Title - Sujet Potable Water System Upgrade	
Solicitation No. - N° de l'invitation EZ899-133386/A	Amendment No. - N° modif. 002
Client Reference No. - N° de référence du client	Date 2013-03-27
GETS Reference No. - N° de référence de SEAG PW-\$PWY-005-6947	
File No. - N° de dossier PWY-2-35368 (005)	CCC No./N° CCC - FMS No./N° VME
Solicitation Closes - L'invitation prend fin at - à 02:00 PM on - le 2013-04-04	Time Zone Fuseau horaire Pacific Daylight Saving Time PDT
F.O.B. - F.A.B. Plant-Usine: <input type="checkbox"/> Destination: <input checked="" type="checkbox"/> Other-Autre: <input type="checkbox"/>	
Address Enquiries to: - Adresser toutes questions à: Pillay, Sal (PWY)	Buyer Id - Id de l'acheteur pwy005
Telephone No. - N° de téléphone (604) 775-9386 ()	FAX No. - N° de FAX (604) 775-6633
Destination - of Goods, Services, and Construction: Destination - des biens, services et construction: CSC - William Head Institution - Metchosin, BC

Addendum # 1

1. Drawing C001 – Civil Site Plan and Details

William Head Institution – Potable Water System Upgrade

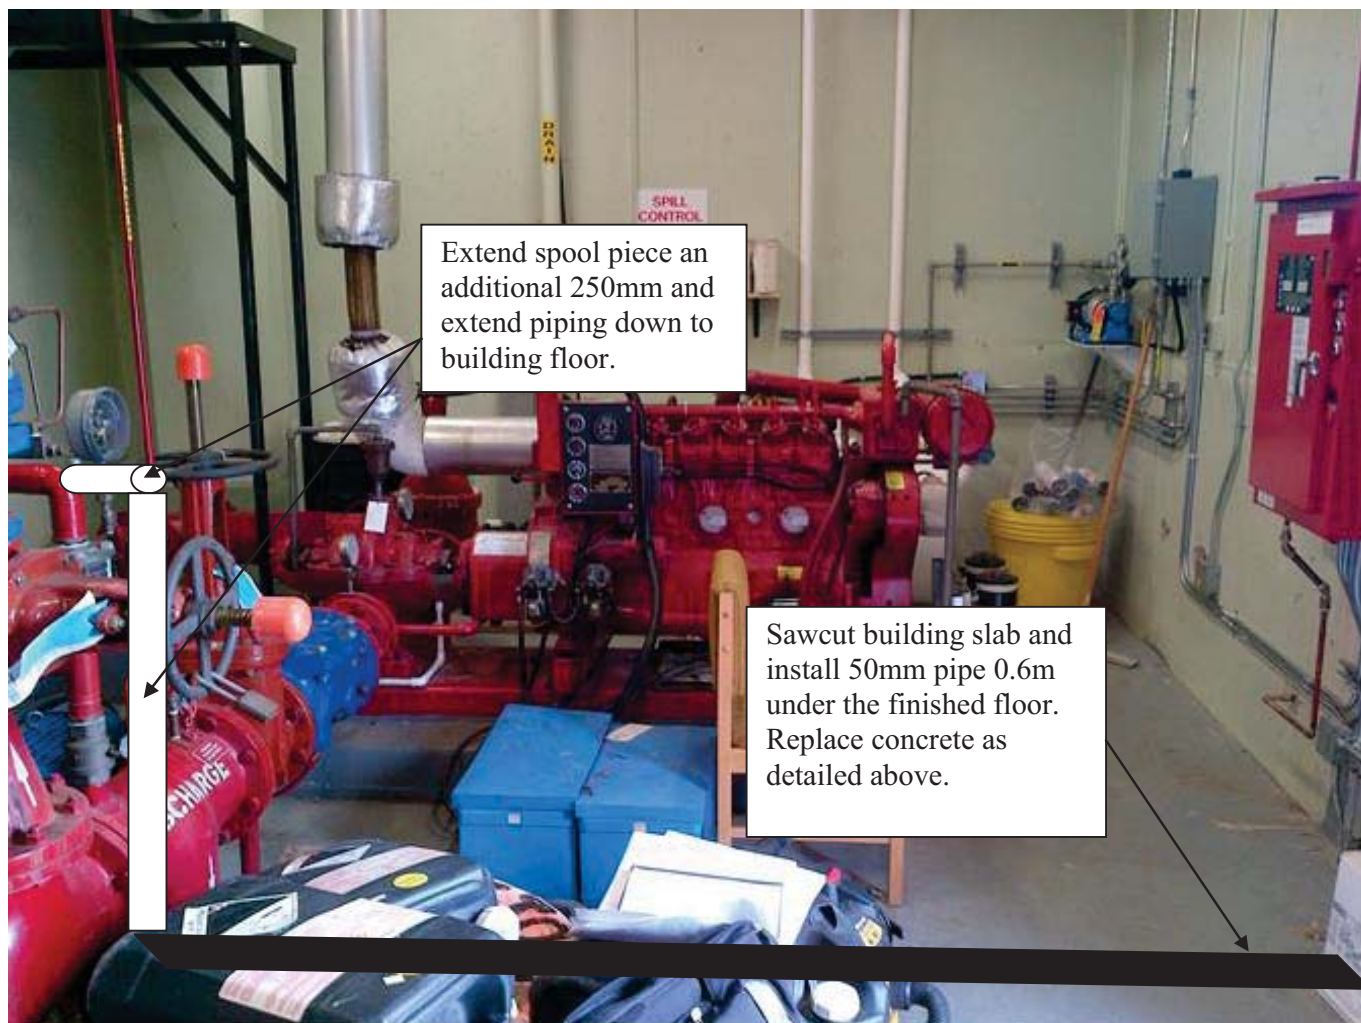
Extend spool piece an additional 250mm and extend piping down to building floor.

Extend spool piece an additional 250mm connect to new piping extending to floor.

Remove valve and cap pipe from 250mm diameter fire line

- 1.1. Delete Construction Note 11. The pre-tender meeting is not mandatory.
- 1.2. Replace Construction Note 11 with the following:
 - 1.2.1. *“Flow from the booster pump and recirc pump to be disconnected from its current tie-in to the new PRV chamber. Exact alignment of 50mm diameter watermain from Building 110 to New PRV chamber to be confirmed on-site with Departmental Representative. Plumbing work required in Building 110 is as detailed below and indicated on the attached photographs. All piping within building is to be new 50mm diameter PVC Schedule 80:*

- *Remove the valve that connects to the 250mm diameter cast iron discharge piping and cap the pipe from the discharge line.*
 - *Extend the spool piece of 50mm pipes that come from the jockey pump and recirc pump discharges an additional 250mm diameter further towards the entrance door of the building prior to connecting to the shared 50mm diameter pipe which extends down to the floor.*

- *Extend the 50mm PVC piping down to the building floor south of the 250mm diameter discharge line. Sawcut and remove the existing building floor (0.6m wide trench) and install new 50mm diameter PVC line at 0.5m depth below finished floor elevation. Align pipe to exit building through doorway to avoid walls.*

- *Replace concrete slab to existing thickness (150mm). Embed and epoxy 15M rebar 150mm minimum into the existing slab 600mm o.c. at mid depth.*
 - *Include 15M rebar running parallel to slab sawcut line at 600mm o.c. Include minimum of 2 per trench*

- *Core through the foundation wall for the pipe protrusion.*
 - *Install Robar Coupling 1.0m outside building to connect to 50mm diameter PVC pipe outside the building to the new PRV building.*
